NewBrain Add. card.

Changing the NewBrain Main Board.

Fig 1. Connection and component placement.

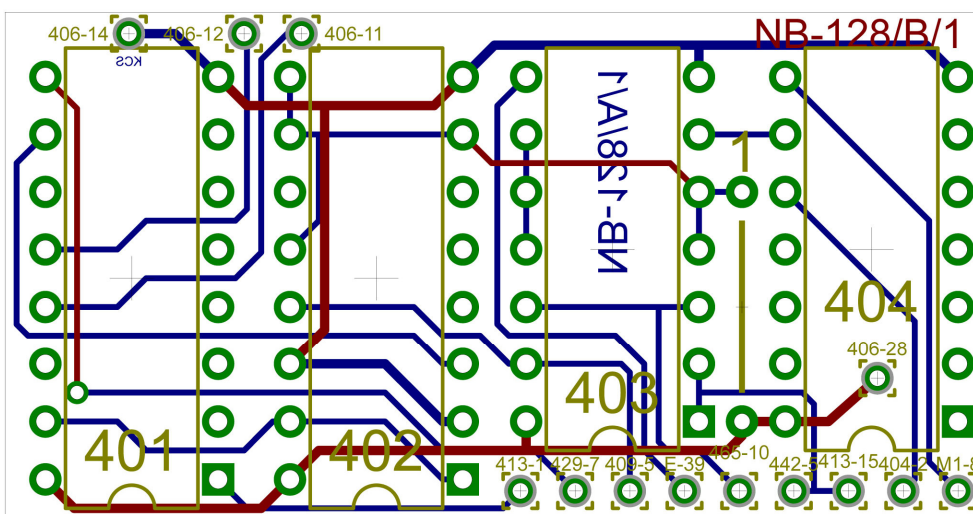
- 6 EPROM IC 407 is replaced by an graphic ROM V2,0
 - 7 Memory card replaced with new 128Kb card.
4. All connections between ADD card and main card installed according to Fig. 1
